DWG. NO. L1571 REV. 3

TITLE FOOT PRINTS FOR BOLT TOGETHER UNITS				TOLERANCES UNLESS OTHERWISE NOTED 2 DEC. PLACES ±/− FOR 3 DEC. PLACES ±/− FOR ANGLES 1/4° FOR NTS				 <small>INDUSTRIAL FABRICATORS VERONA, NJ 07066</small>	
DRN BY ME	DATE 12-23-97	CHKD BY JJ	11	SH. 1 OF 1	DWG. NO. L1571	REV. 3

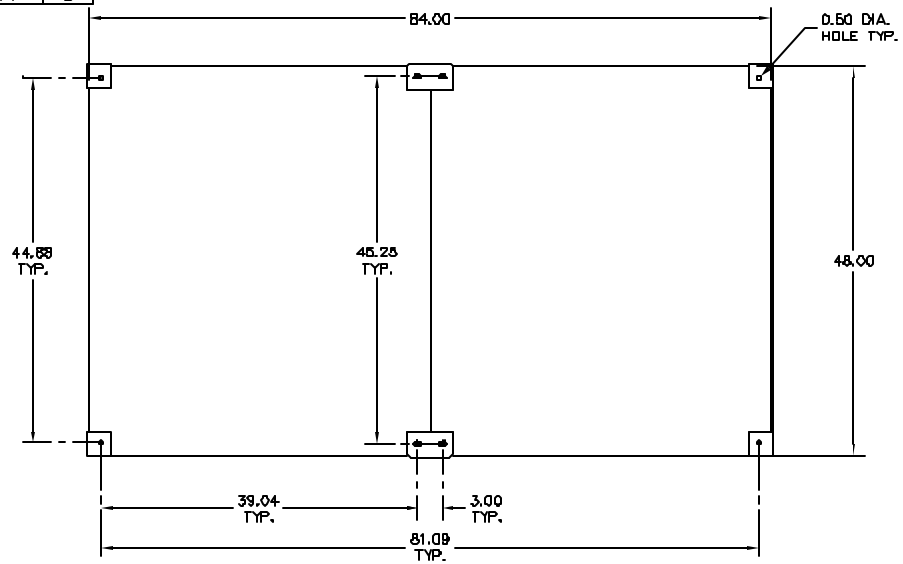
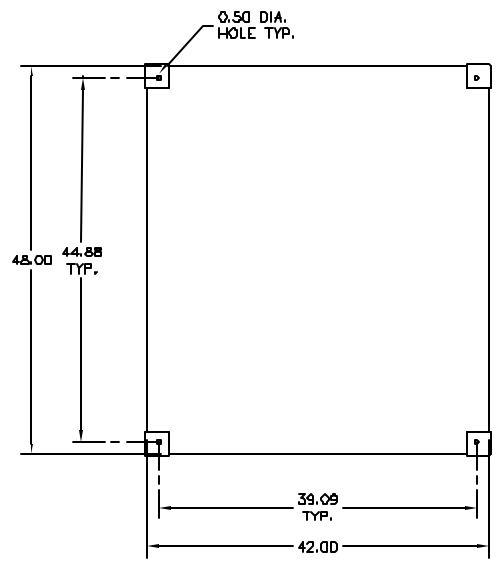
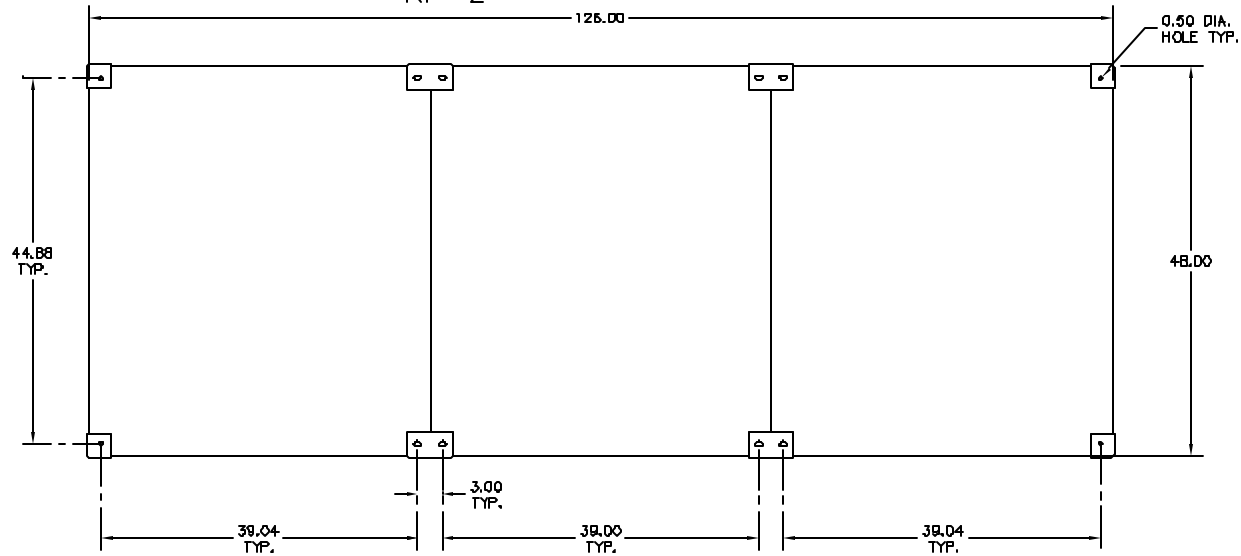
REVISIONS		
2	17-20-98	MC (EDR 9690)
CHG. TO NEW LEGS. CHG. DIM'S: 45.40 WAS 38.00; 39.30 WAS 33.50; 81.60 WAS 88.00; 39.00 WAS 35.00.

3	8-25-98	MC (EDR 8132)
CHG. LEG HOLE PLACEMENT DIM'S CHG.
